REQUEST FOR PROPOSAL (RFP)
Municipality of the County of Colchester
Parking Design - Fundy Discovery Site

ADDENDUM #1 - Issued September 28, 2026

SITE PLAN

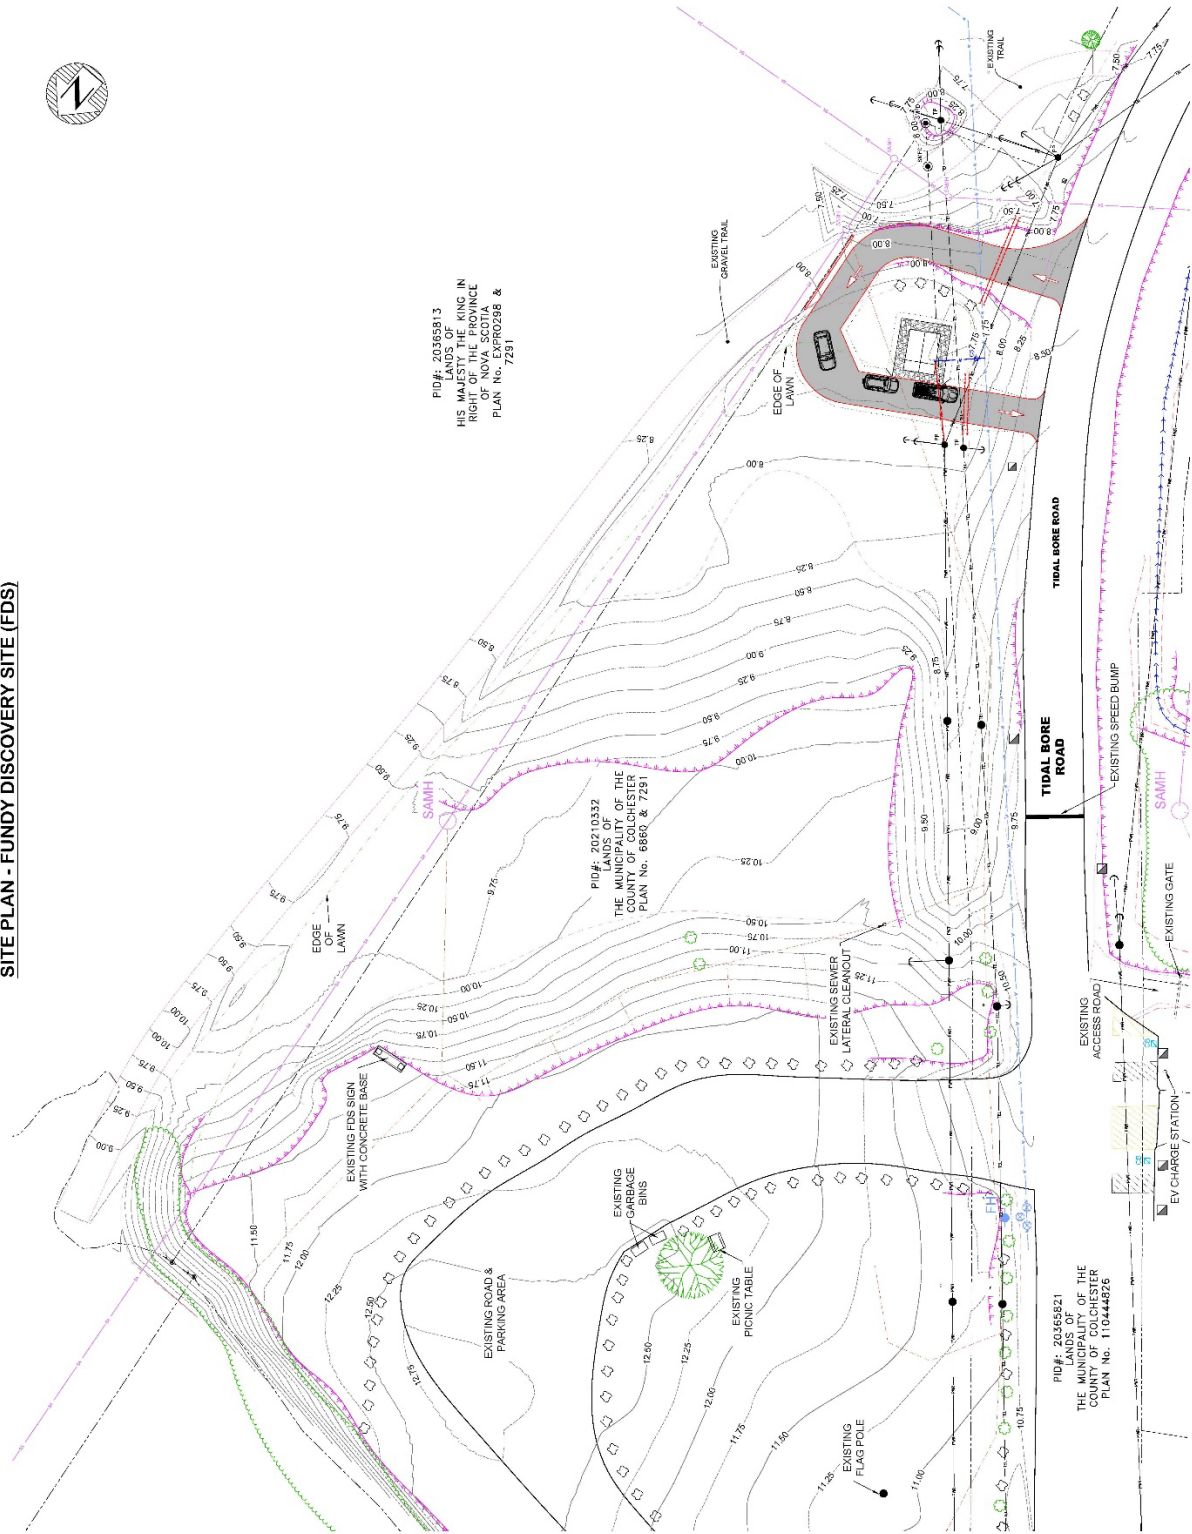
Question: Please clarify which portion of the project area is included in the existing topographic survey and whether it captures sufficient information to support detailed design of the proposed parking areas, including existing grades, surface features, drainage features, utilities and other relevant site conditions.

Related Question: The RFP mentions that a "topographic plan (AutoCAD) of a portion of the project site" will be made available to the successful proponent. Can this be provided in advance, so proponents can determine the scope of any additional topographic survey that may be required?

Answer: Re: Section 2.4, third point, "Topographic plan (AutoCAD) of a portion of the project area". The limit of the existing topographic survey is shown on the drawing attached. The existing topographic survey CAD file will be provided upon project initiation. The existing topographic survey captures sufficient information to support detailed design of the proposed parking areas, including existing grades, surface features, drainage features, utilities and other relevant site conditions.
